MEMORANDUM

RE: Vanderwall Residence Remodel, City of Mercer Island Permit Number: 2101-202

This memo summarizes my responses to the various structural items shown on the City of Mercer Island Corrections Notice dated May 6, 2021.

Attachment C

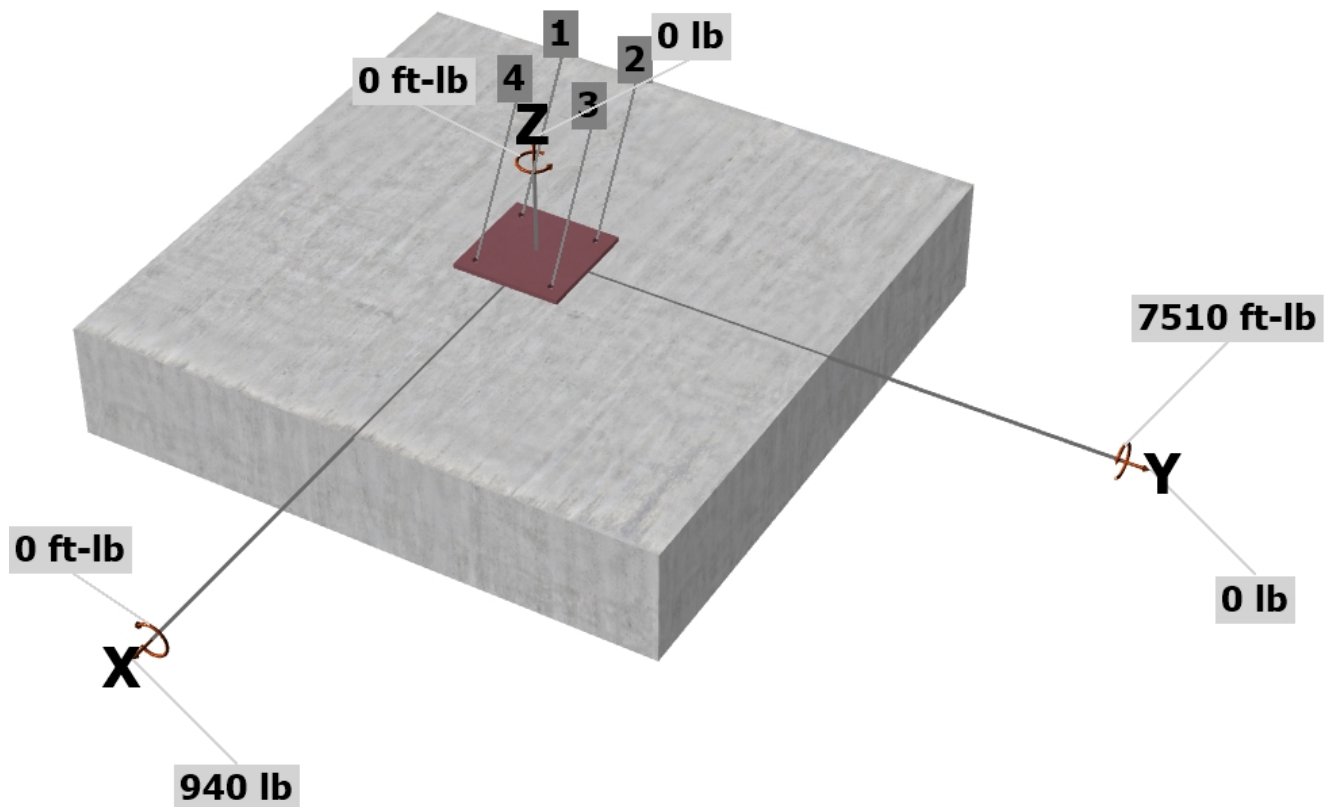
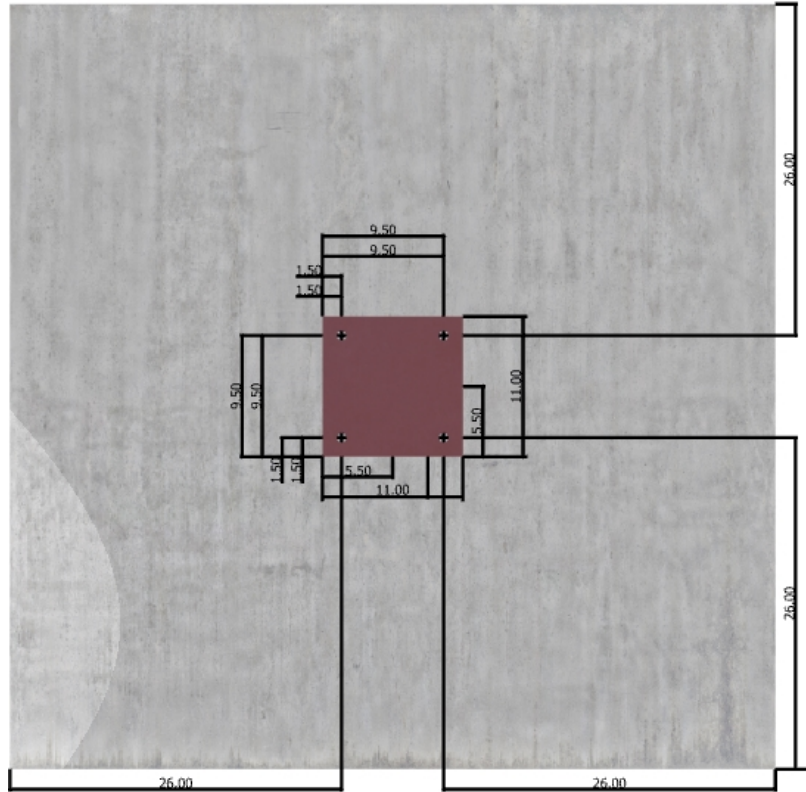
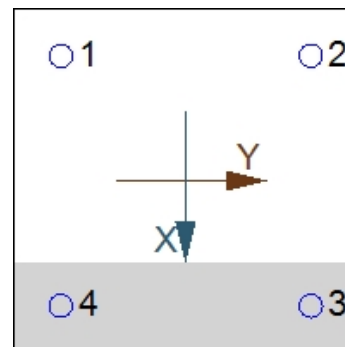
- S2.3** 1) *Please review anchor design. Shouldn't applied moment be M_y , not M_z ?*

See **Attachment C** calculations showing applied moment in correct direction.

N_{ua} [lb]: 0
 V_{uax} [lb]: 940
 V_{uay} [lb]: 0
 M_{ux} [ft-lb]: 0
 M_{uy} [ft-lb]: 7510
 M_{uz} [ft-lb]: 0
